## TEXAS COMMISSION ON ENVIRONMENTAL QUALITY

Re: Fort Bliss Solid Waste Landfill – El Paso County  
Municipal Solid Waste (MSW) - Permit No. 1422  
Permit Modification – Evapotranspiration (ET) Final Cover Notice of Deficiency (NOD)  
Tracking No. 15183873; RN100210095/CN600126262

**Re: Fort Bliss Solid Waste Landfill – El Paso County  
Municipal Solid Waste (MSW) - Permit No. 1422  
Permit Modification – Response to Evapotranspiration (ET) Final Cover Notice of  
Deficiency (NOD)  
Tracking No. 15183873; RN100210095/CN600126262**

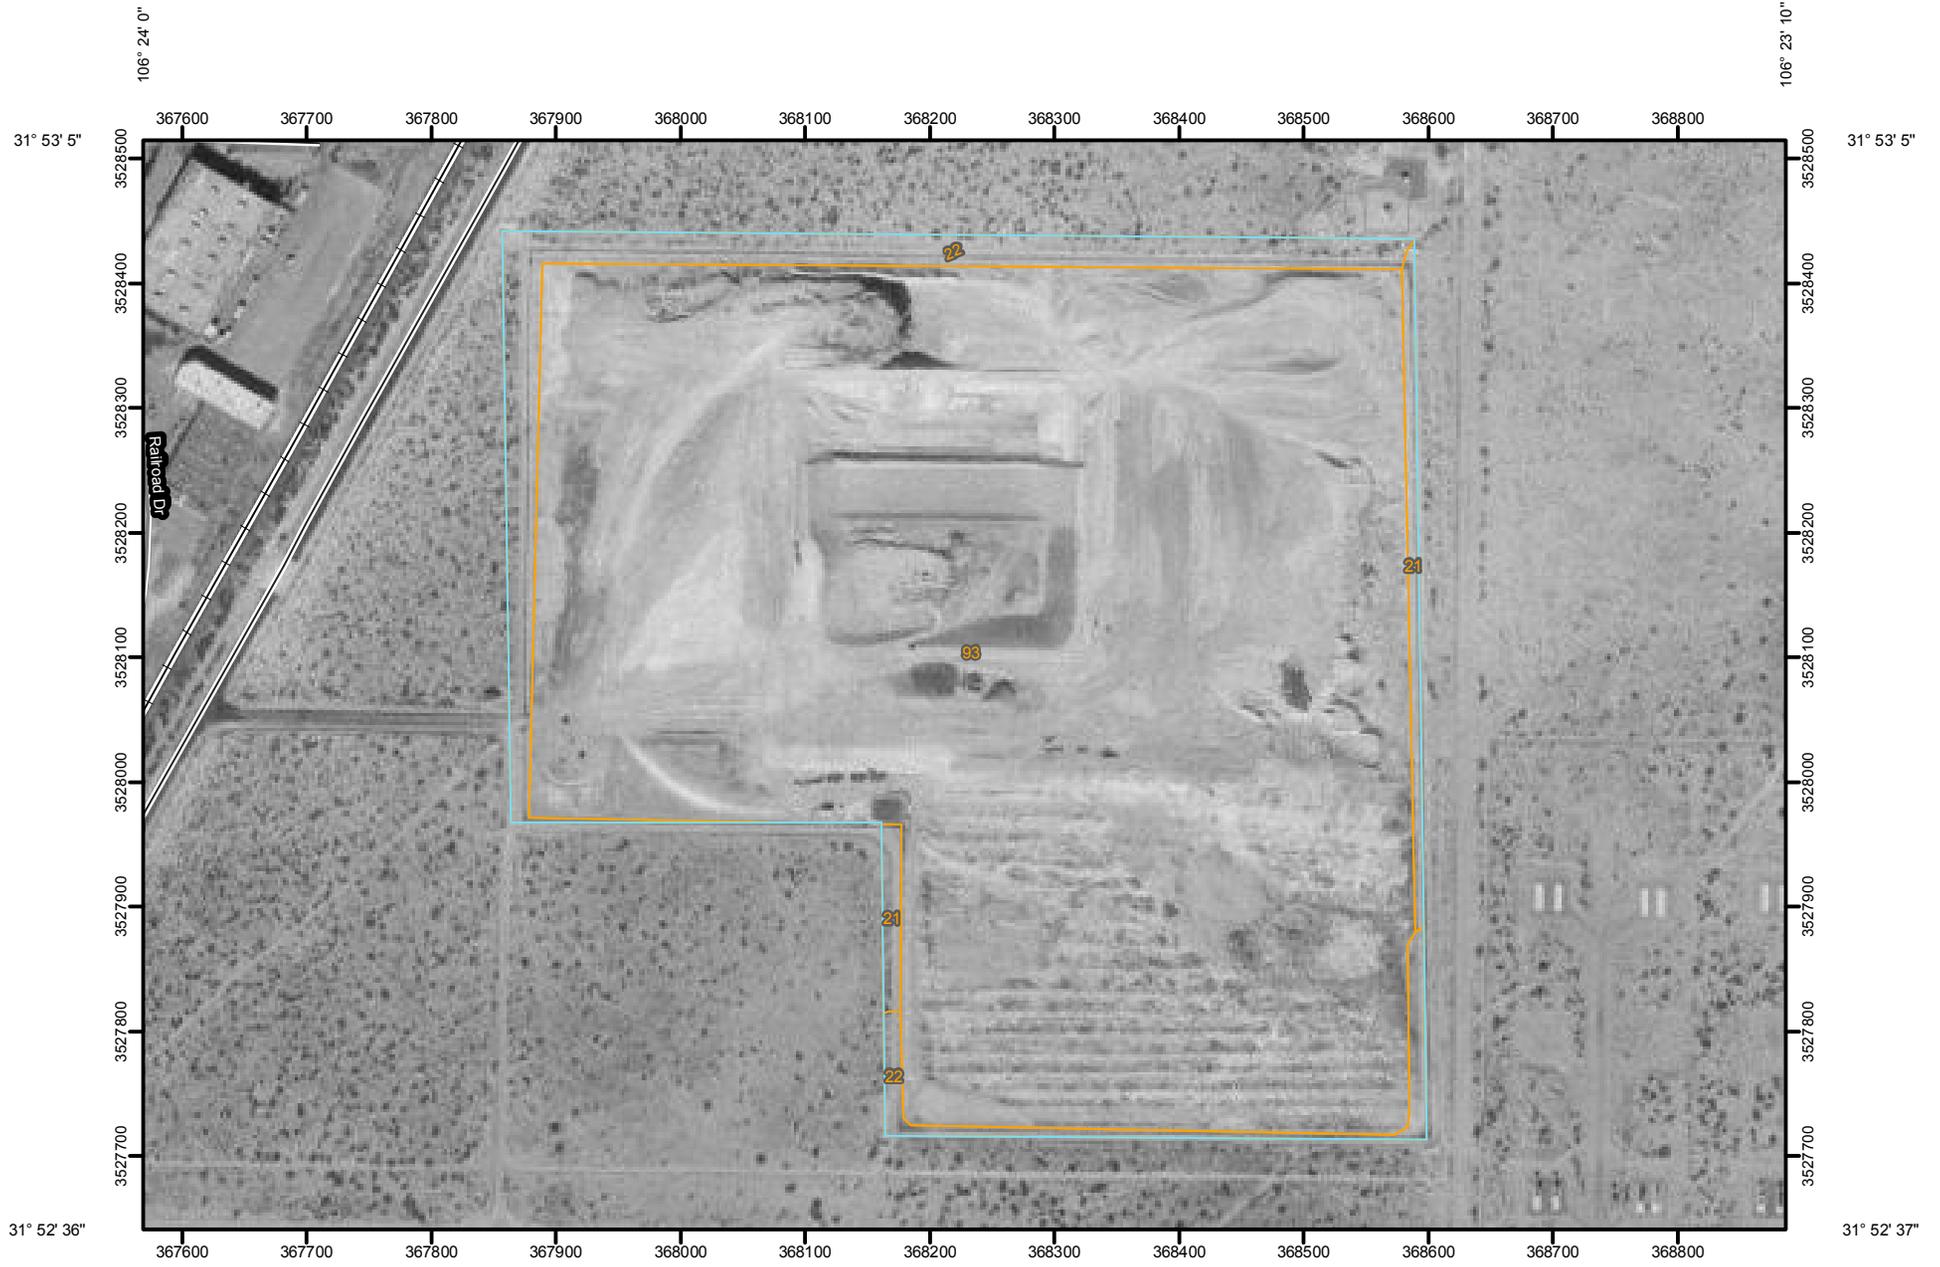
4. The revisions made to address Comment No. 53 of our November 22, 2011 NOD letter appear to only cover compaction rate. Please discuss how the parameter values (for example, the saturated hydraulic conductivity) specified in Appendix Q for the ET layers will be satisfied (please consider the QC/QA measures included in Section 5 of Appendix 0, and specify proper ranges for the parameter values).

*The laboratory reported the gradation and hydraulic properties of the composite on-site soil for varying compaction rates in an effort to identify the optimal ET cover section and compaction requirements. Therefore, quality control and quality assurance (QA/QC) testing requirements prior to and during the final landfill closure construction were focused on the gradation, hydraulic properties (saturated hydraulic conductivity, saturated water content, residual water content), and compaction of the ET final cover soil to ensure that the ET final cover will be constructed in accordance with the design intent to maximize ET performance.*

*The sieve analysis of the composite soil sample indicated that the soil classifies as silty sand (SM) in accordance with ASTM D 2487. Additional site-specific sieve analysis data from 2008 was reviewed and confirmed that existing on-site soils are classified as silty sands (SM), clayey sands (SC), or other combinations thereof. The EPA published UNSODA Unsaturated Hydraulic Database (Leij, Alves, and van Genuchten, August 1996) indicates that soils that fall within similar USCS Classifications can be expected to perform similarly from a hydraulic standpoint. To verify this assumption, van Genuchten parameters were back-calculated from the 2008 on-site sieve analysis data by methods published by Aubertin (2003) and compared to the laboratory-reported composite sample values. Additionally, estimates of typical unsaturated hydraulic properties for similar soil textures reported in the UNSODA manual were considered for consistency verification. All referenced values were of the same order of magnitude as the laboratory-reported data, indicating that the on-site soils can be expected to perform similarly.*

*To ensure performance of the constructed ET cap is similar to that modeled, QA/QC requirements included in this Closure Plan were expanded to include verification of gradation and hydraulic properties of the materials to be used in the ET cap. In addition, the UNSAT-H model was further evaluated for sensitivity to individual input parameters based on the back-calculated and published data to identify material property requirements that must be met in order to be considered acceptable for use in the ET cover. The construction QA/QC section of Appendix O has been revised to further detail the required gradation testing based on this additional analyses. Should existing on-site soils not meet the material requirements, additional screening and processing of soils will be allowed pending additional QA/QC testing at the required frequencies.*
